RE: John Street Pond Feasibility Design Analysis Report
Engineer's Stamp Date: 11/09/23
Hydrology File: L14D067

COMMENT RESPONSE LETTER

RE: John Street Pond Feasibility Design Analysis Report
Engineer's Stamp Date: No date
Hydrology File: L14D067

JOHN STREET POND FEASIBILITY DESIGN ANALYSIS REPORT

Figure 3: Existing Subbasin Map

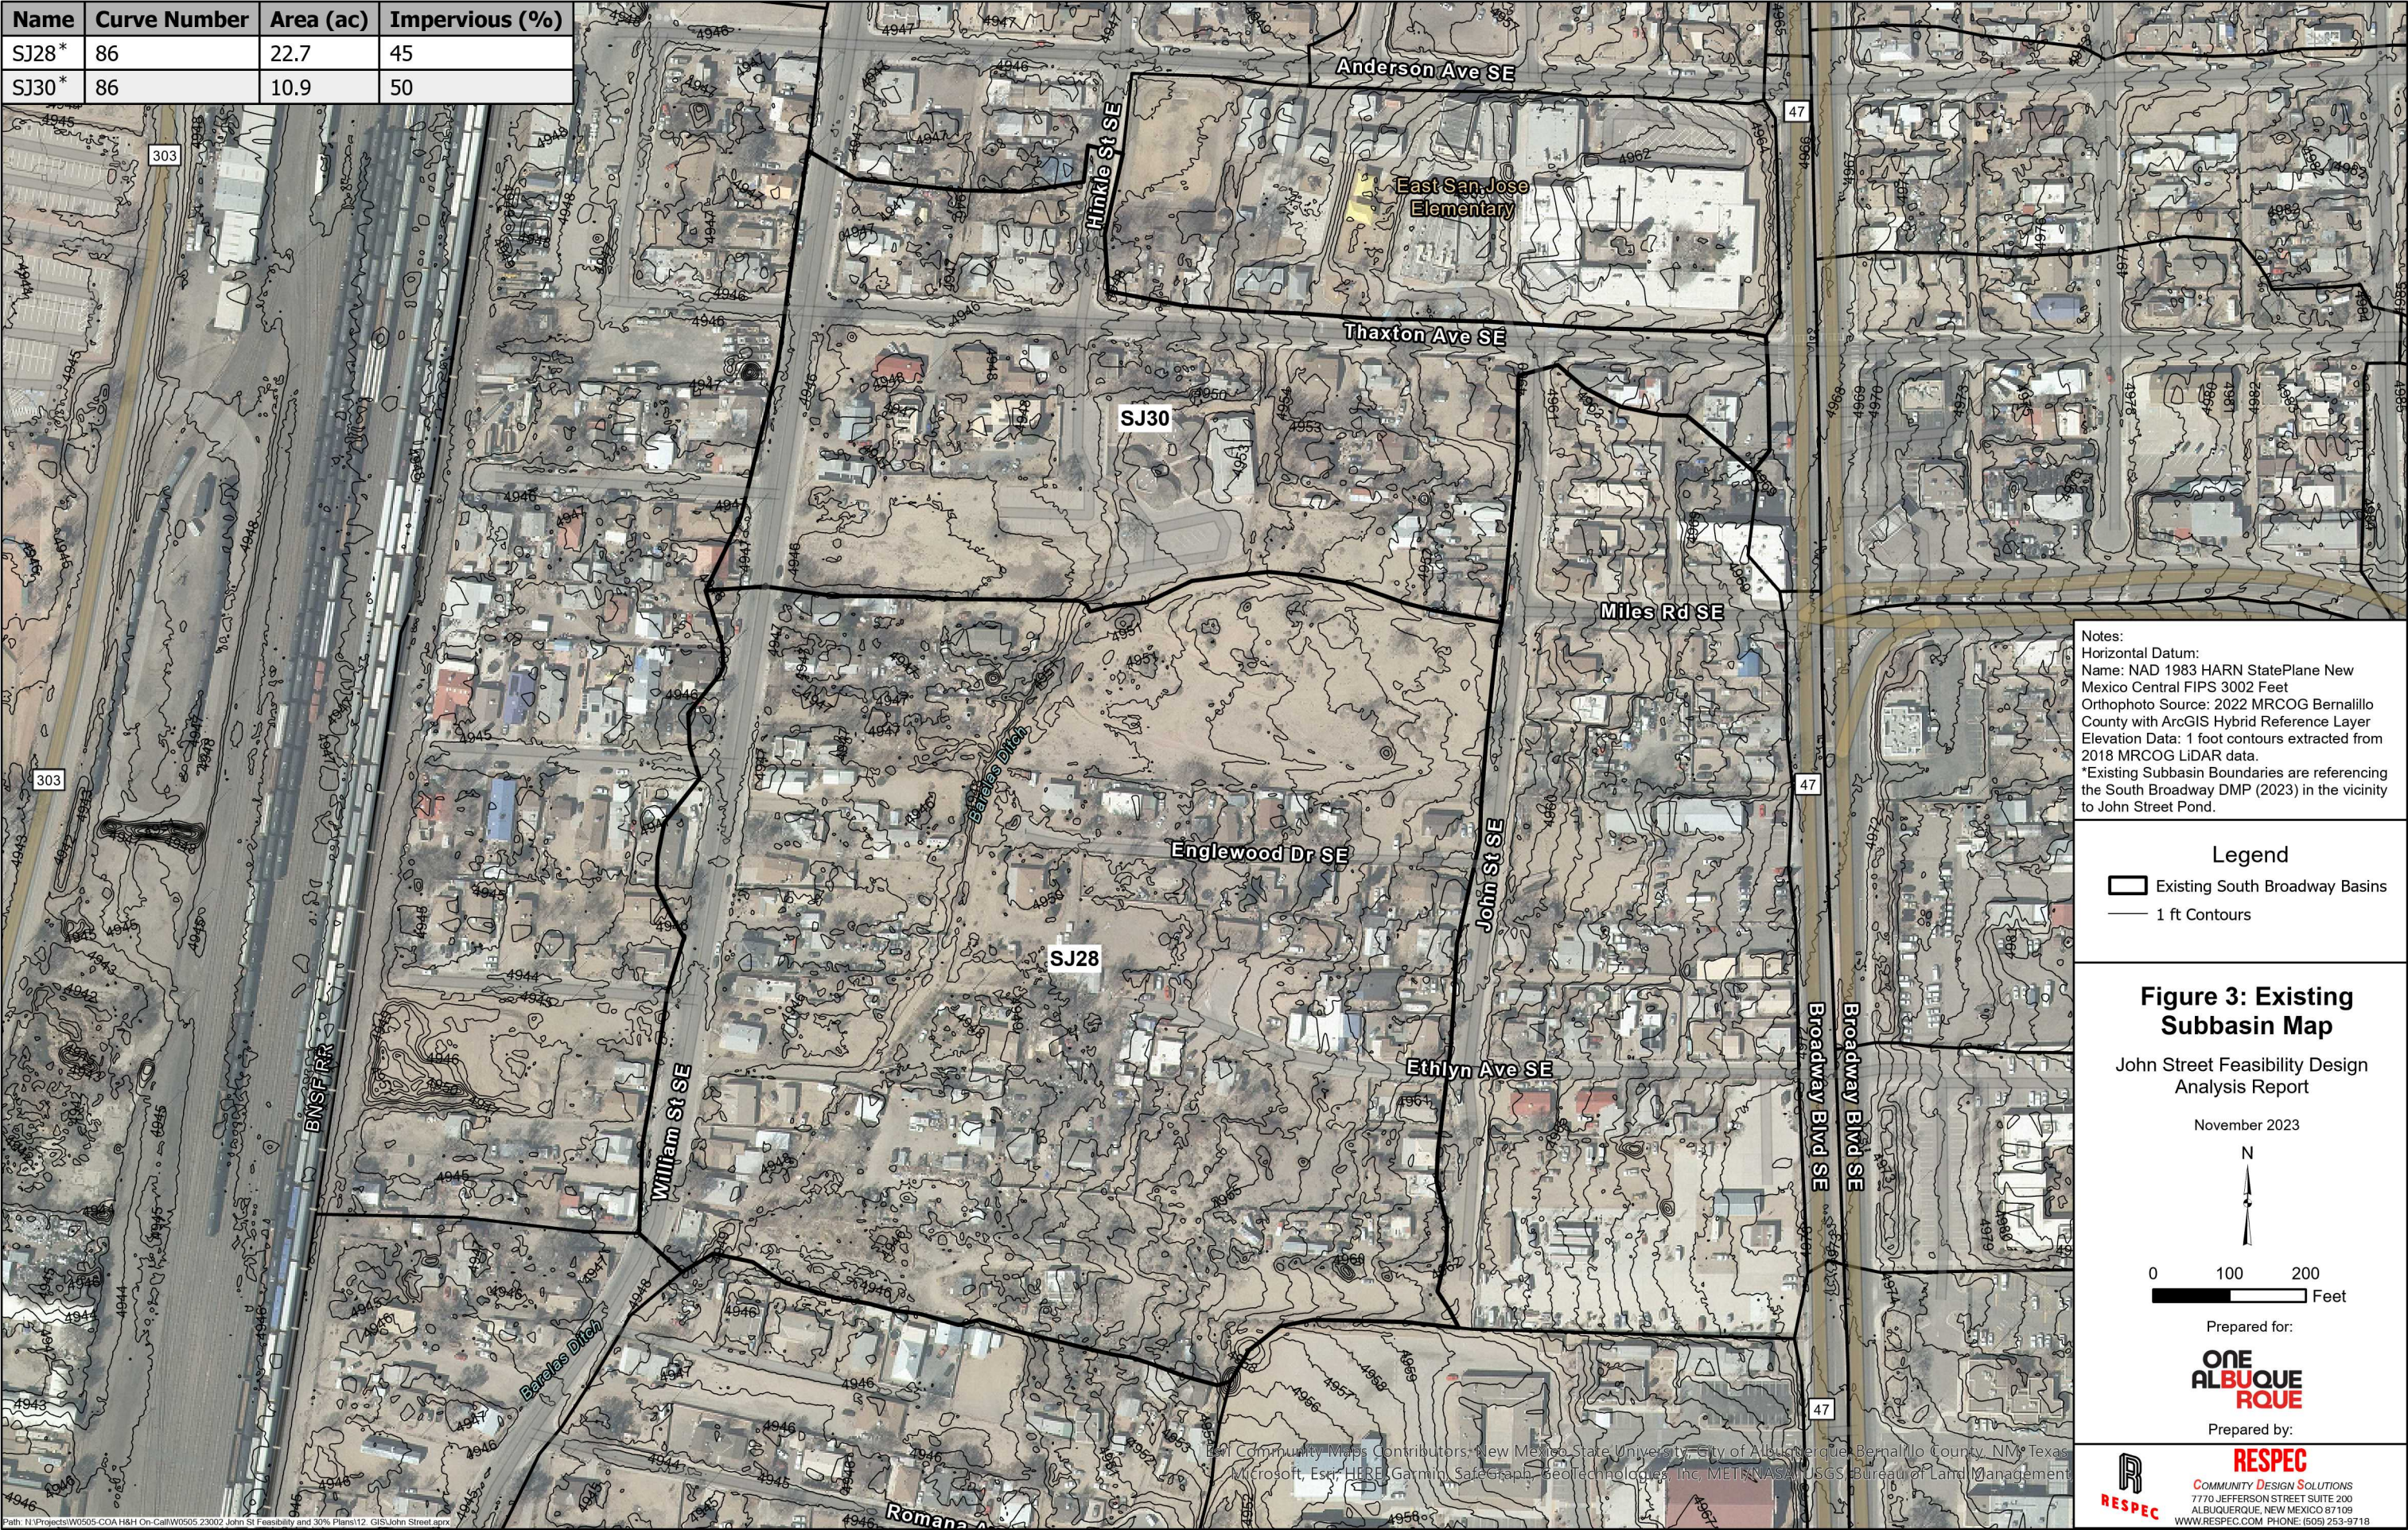
3. In 2.1 Existing Conditions, the section just refers to the updated SBDMP without a map. A map showing the existing subbasins similar to Figure 3 (Proposed Subbasin Map) would be helpful. [A figure showing existing conditions subbasins in the vicinity to John Street Pond was added to the report.](#)

Figure 4: Proposed Subbasin Map
John Street Feasibility Design
Analysis Report
November 2023

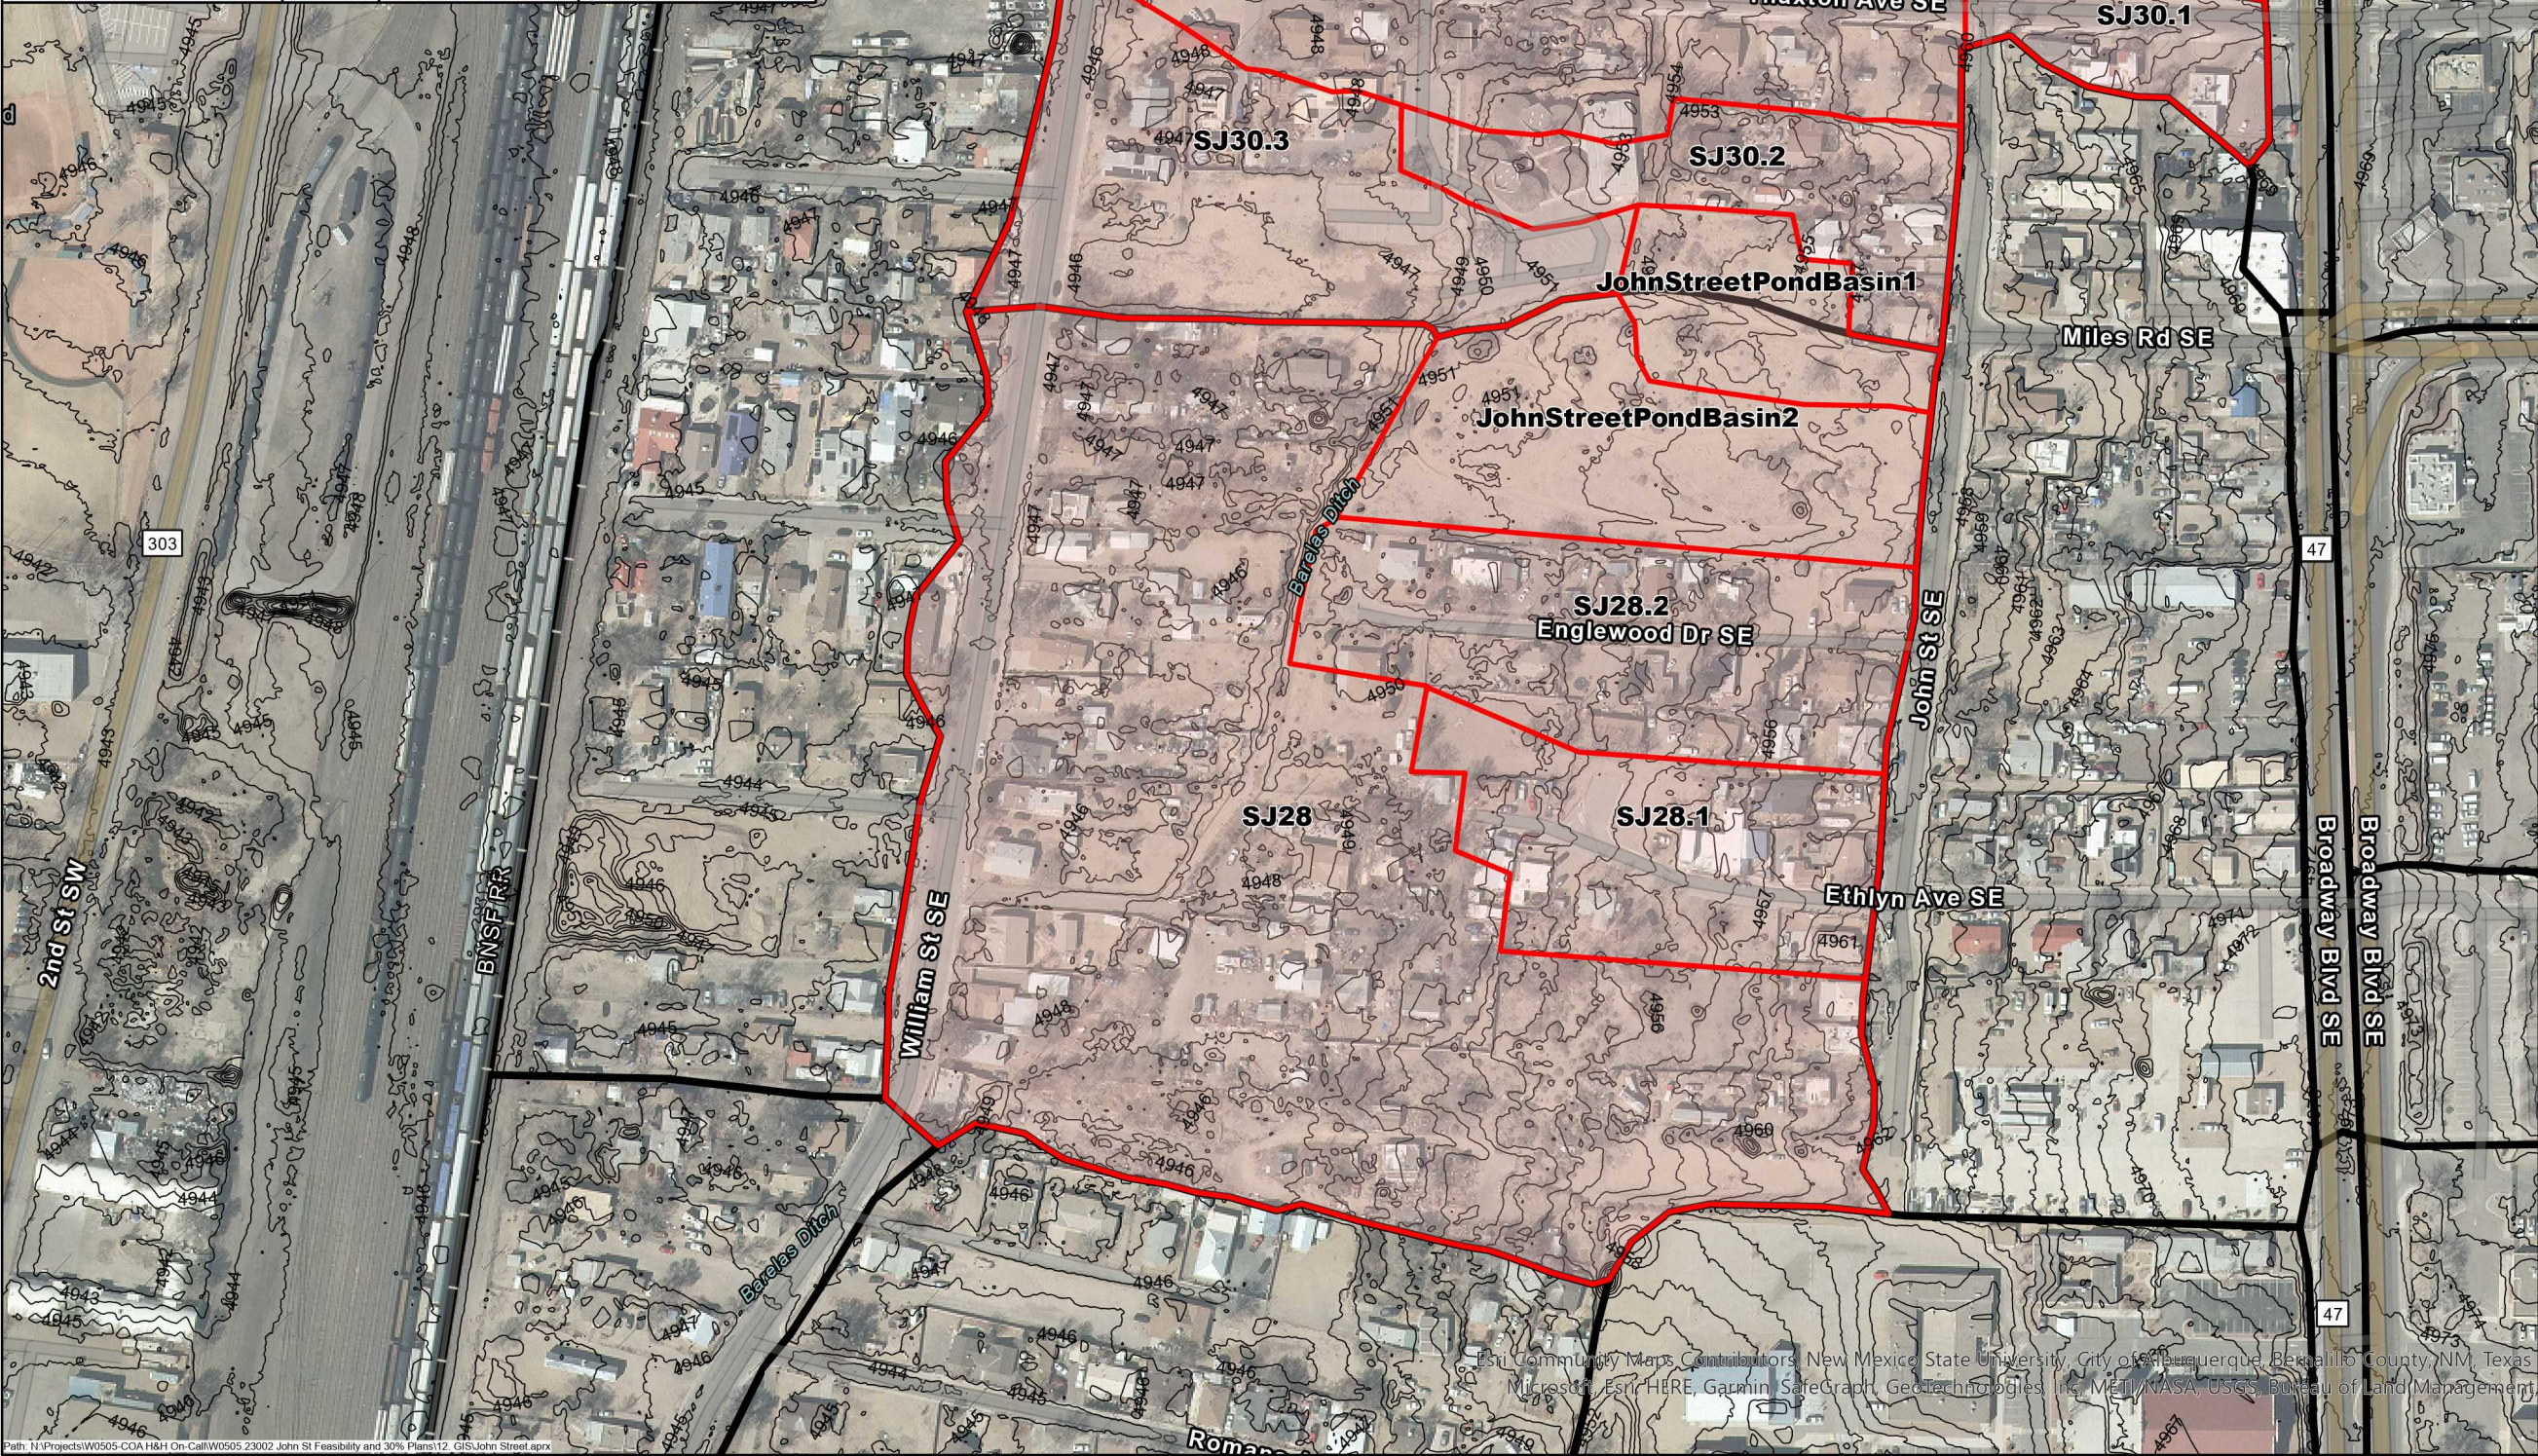
4. In 2.2 Proposed Conditions, why are all the Curve Number (CN) the same? Hydrology section has found if you are using a soil map within Albuquerque, then the resulting flows are off. As in the DPM, Hydrology Section recommends using the following CNs depending on the land treatment and using a weighted CN.

- a. The use of just four Curve Number (CN) values, one for each of the land treatments already described in the DPM: A=76, B=80, C=85 and D=98. This way the hydrologic soil groups don't need to be determined to select the CN and the soil maps do not need to be consulted.

- b. For example, John Street Pond Basin 1 has 85% impervious but uses a CN 86. If you use a weighted CN, then you get $0.85 \times 98 + 0.15 \times 85$ which gives a CN 96.

c. For example, John Street Pond Basin 2 has 20% impervious but uses a CN 86. If you use a weighted CN, then you get $0.20 \times 98 + 0.80 \times 85$ which gives a CN 87.6.

As you can see using the weighted CN gets a more accurate representation of the existing conditions or proposed conditions. RESPEC maintained the same hydrology procedures discussed in the Alameda SWMM Drainage Study (October 2022) report, which is also referenced in the South Broadway DMP (March 2023). The Alameda SWMM Drainage Study discusses in depth the hydrology practices and curve number (CN) selection. Below is a screenshot of verbiage from the Alameda SWMM Drainage Study report for context. The subarea routing method used, from the SWMM hydrology manual, was the "impervious method" which routes the directly connected area (roofs to driveways into the street into the storm systems) over pervious area (grass, compacted parking lots, etc.). Since the area around John Street Pond has similar lot sizes, the CN selected was applied to the pervious area of the subbasin. Since the Hydrologic soils report showed a mixture of groups A-D for the watershed, RESPEC conservatively used CNs in HSG C since the drainage area is developed with compacted pervious soils. Therefore, for these lots around the John Street area, RESPEC used an average CN of lot sizes 1/8, 1/3 and 1/4. RESPEC will provide the Alameda SWMM Drainage Study report.
